MEMORANDUM

SUBJECT: KMC "Draft" Quality Assurance Project Plan

Re: Kennecott Hydrogeologic Study Comments

Figure 1 Average TDS from leach o-u-p-s  
To The evaporation ponds.  
- Well number  
- Average TDS for period of record.  
K - KCC new well site  
P - suggested well site  
W - well eliminated

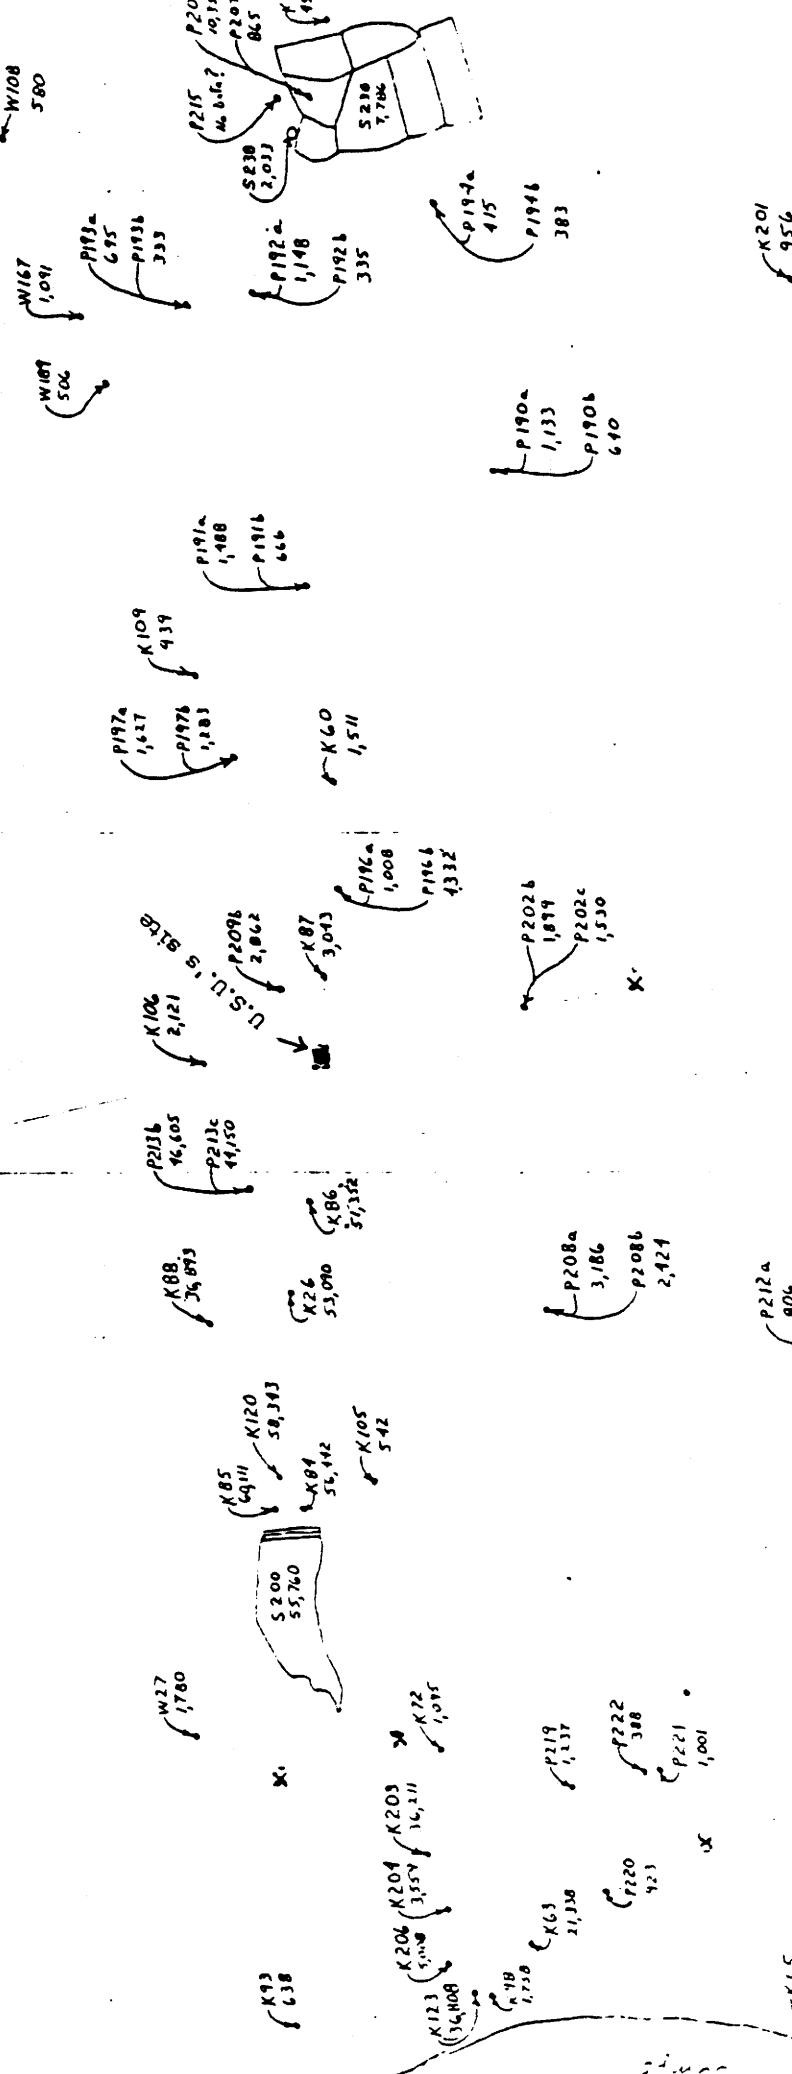
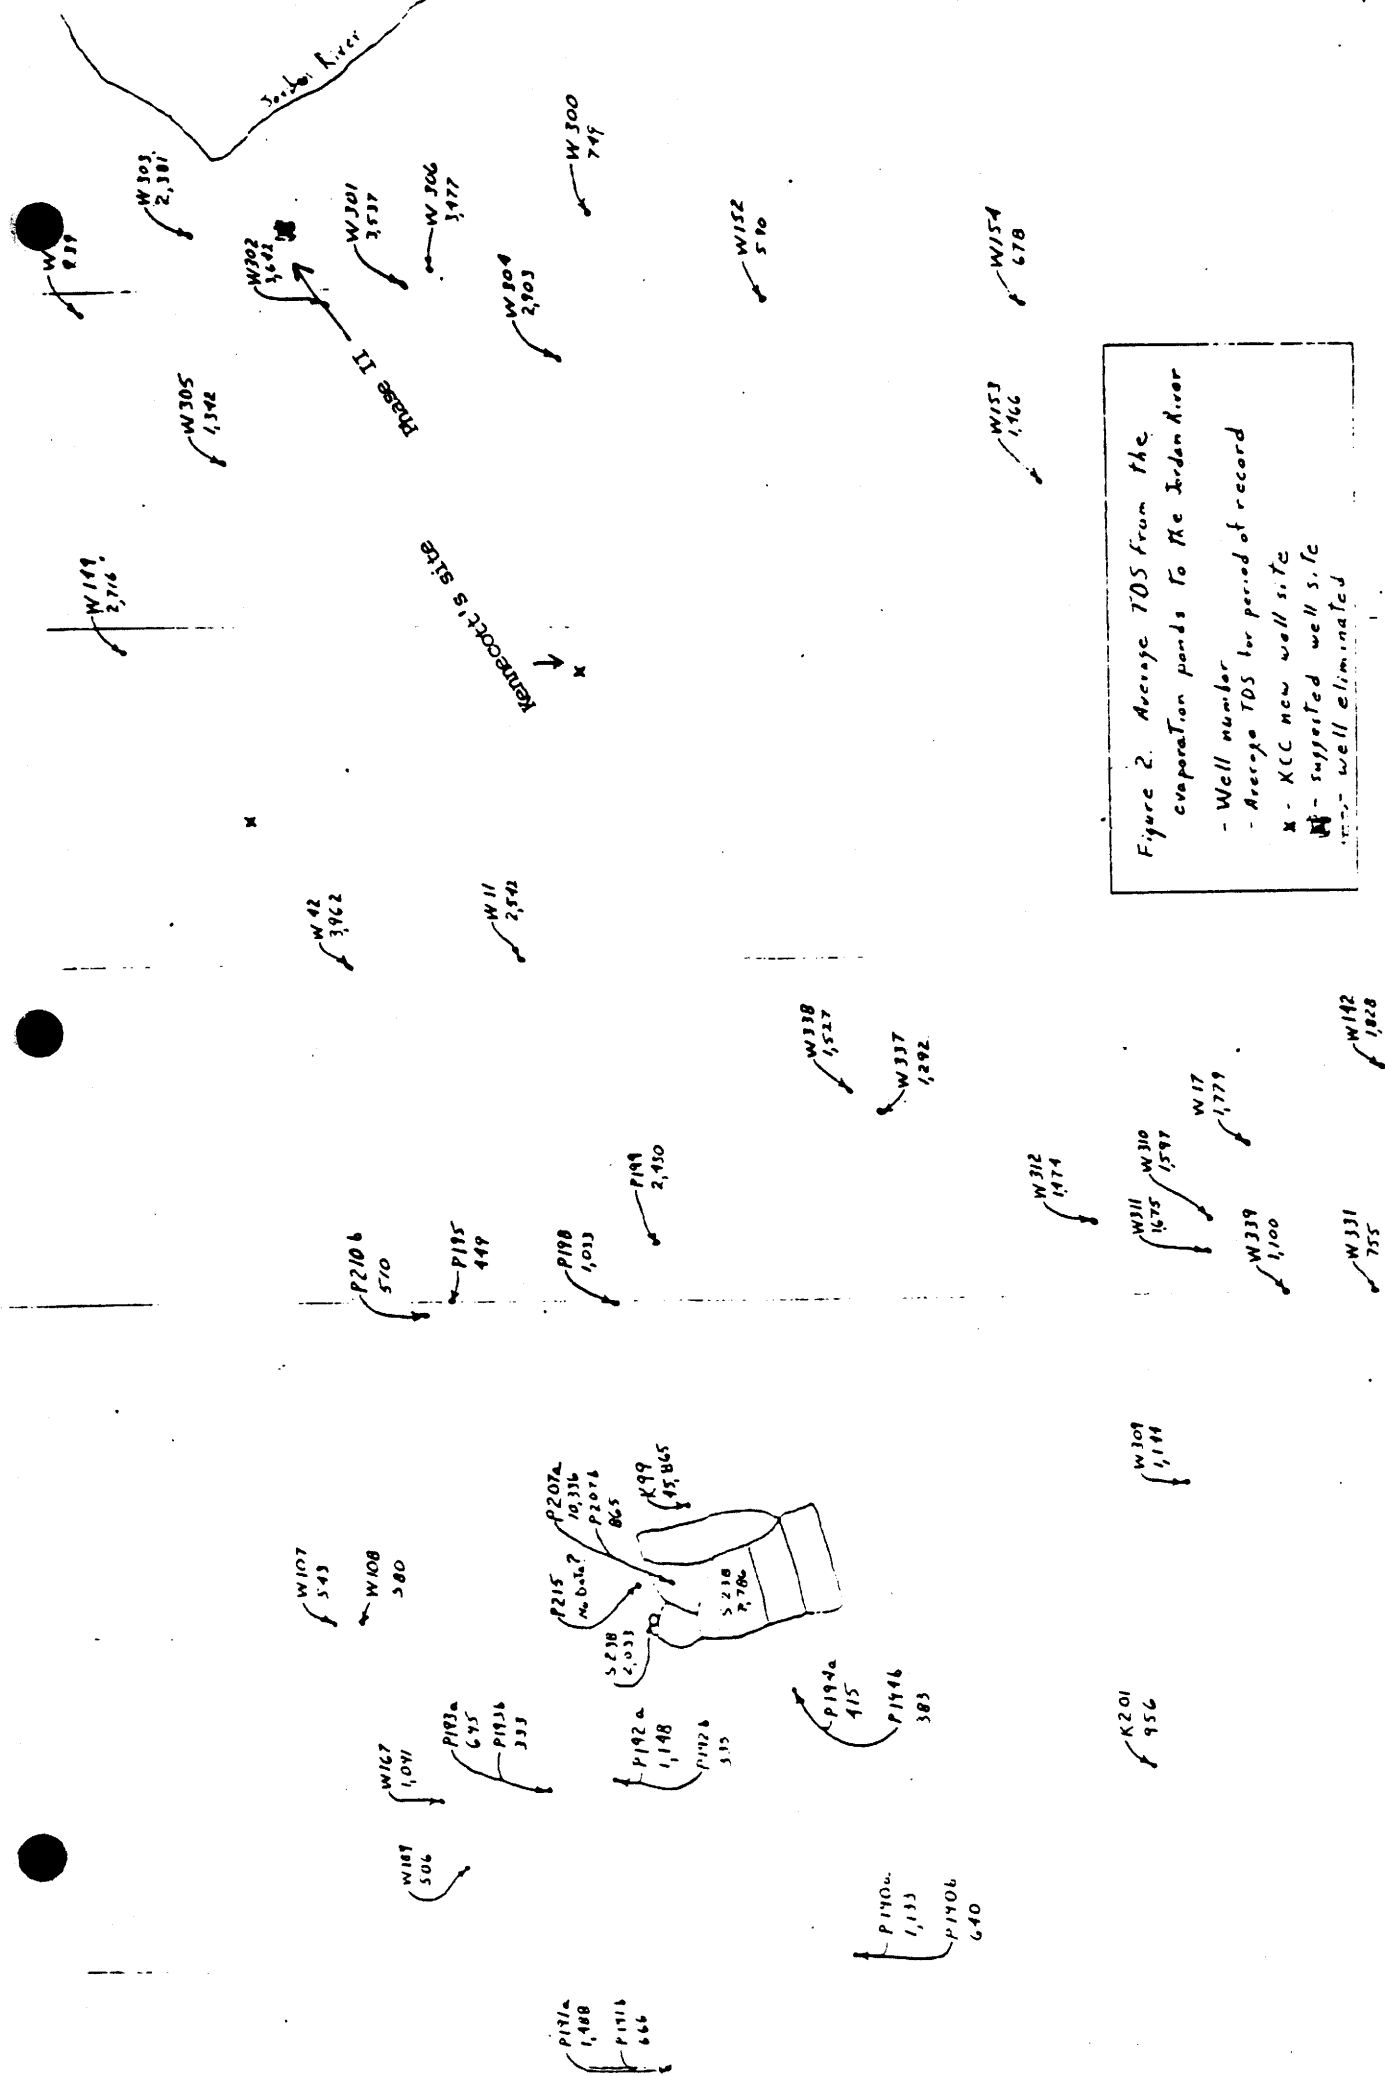
The proposed new monitoring well locations are adequate, with the exception of two areas. The first area is located about 1.25 miles east of the 500 million gallon reservoir. Figure 1 (enclosed) shows that average TDS drops from about 40,000 mg/l to only 2,000 mg/l in a relatively short distance. The front of the plume is either in this area or, the plume is sinking below current monitor wells. We cannot agree with the statement that: "Plume movement along Bingham Creek appears to have stabilized (i.e., reached steady-state conditions) or regressed slightly" (Kennecott's Environmental Assessment Status Report, Oct. 1984, p. 76). Since three of the wells in this area have been eliminated (K86, K87, P196b), a deep, multi-level monitoring well should be installed to make up for this data gap. A suitable location would be between the old K86 and K87 sites, in line with the new wells at (C-3-2) 22 and (C-2-2) 10 as shown in Figure 1. (Phase II.)

should be installed to monitor deeper aquifer zones. A suggested location (Phase II.) is shown in Figure 2 (enclosed).
